SETTLEMENT UPDATE
FOR
MIDLAND PLANT UNITS 1 AND 2
CONSUMERS POWER COMPANY
DOCKET NUMBERS 50-329 AND 50-330

Report Date: September 14, 1980

NRC Position -- Diesel Generator Building
Vu No. 1 CPCo Position No. 1

List of Vugraphs for Diesel Generator Building

Fig. 11

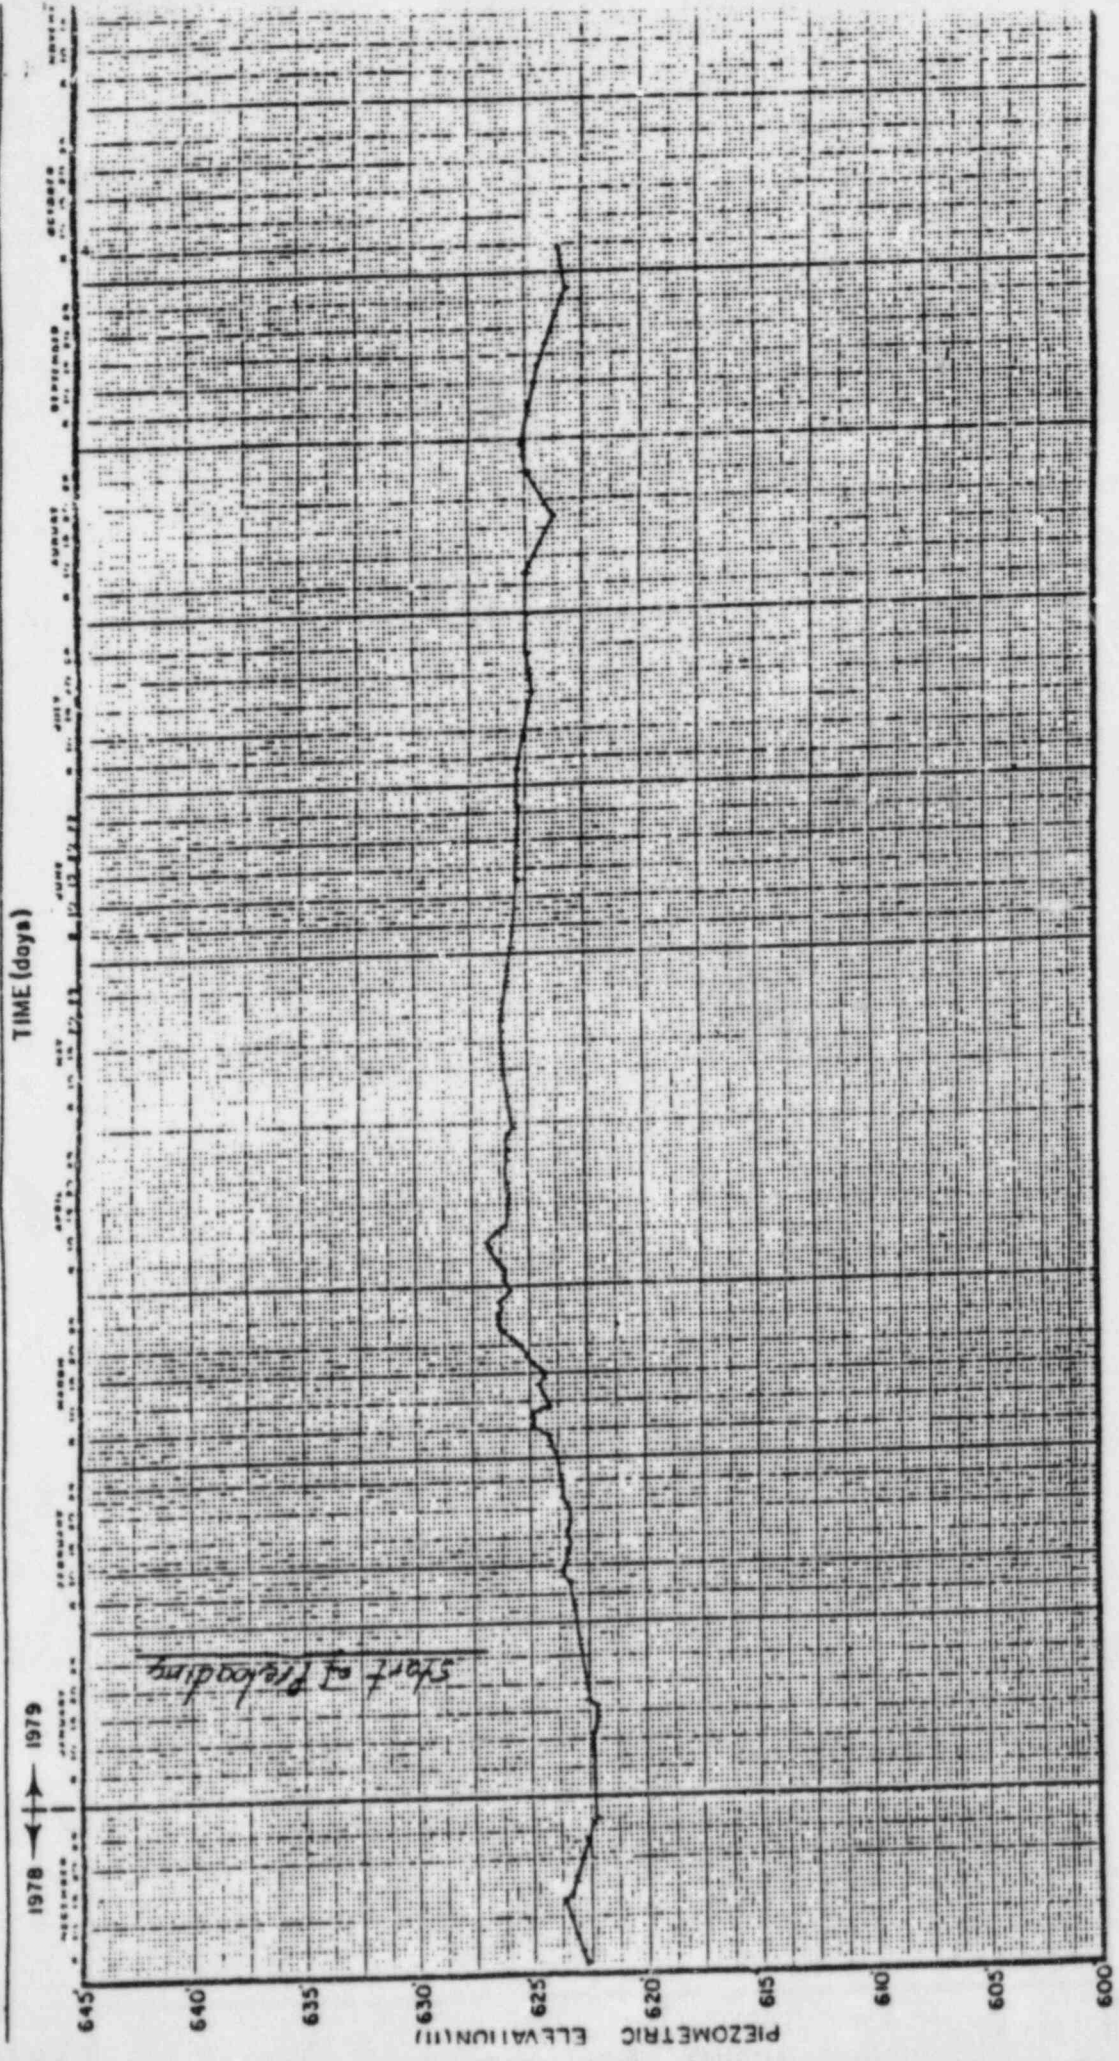
- Show disagreement with previously submitted data (**Vu No. 9**) at critical time of surcharge removal for PZ-30.
 - Show previously submitted Fig 27-5 (**Vu No. 10**) where PZ-23 behavior at time of surcharge removal has been deleted & replaced w/ PZ-30 data but all other data (Settlement of DG-3, pond & surcharge) remains unchanged. Show how PZ-23 supports our concern that secondary consolidation was not reached by observed behavior. Show other piezometers, PZ-36 **Vu No. 11** and piezometer PZ-47 **Vu No. 12**

DIKE SECTION G
(Section of Max. Emb. Height)

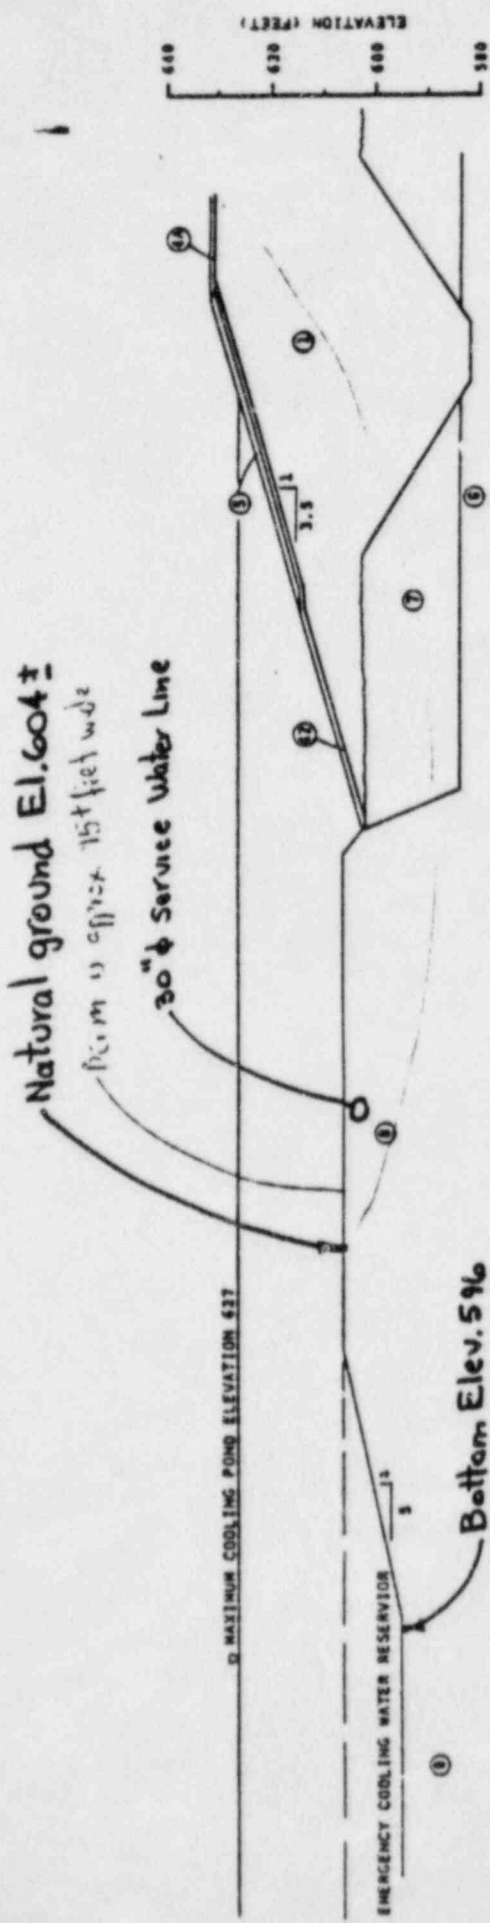
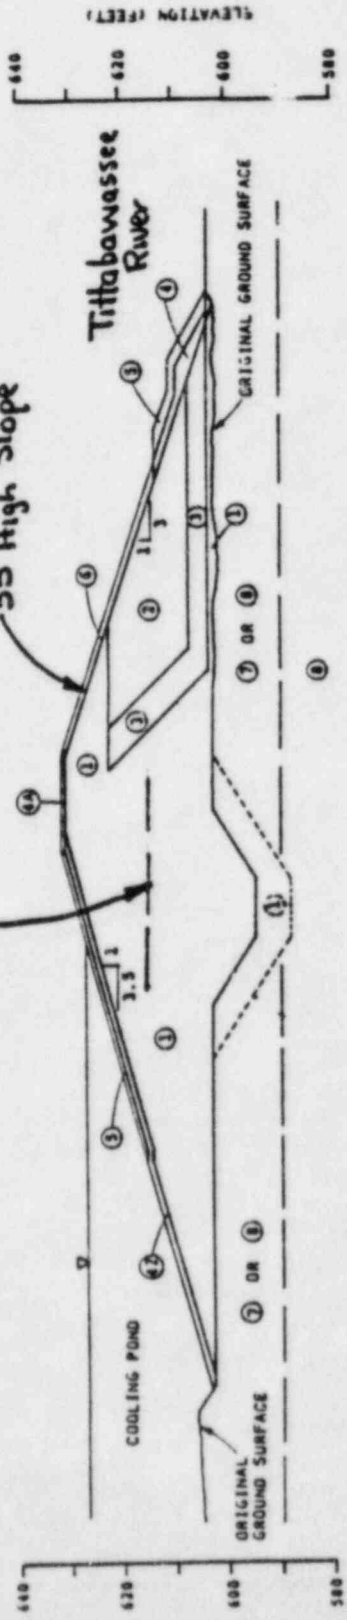
2. NOT safety related. ^{is this saying that the cooling pond structure does not have to demonstrate its ability to withstand seismicity?} NOT a Q-listed structure.

4. No significant settlement problem. ^{Similar statement has been made for Aux Bldg. & SW Ringh. - but being informative.}

Settlement of dike can be an issue if construction of cracking & low oil free bases - but this is not the concern at Midway

5. Borings (not yet furnished to NRC) w/ SPT completed for power poles & piezometer installations indicate stiff clay fill.

6. Possible damage to dike because of requested borings now that pond is filled.
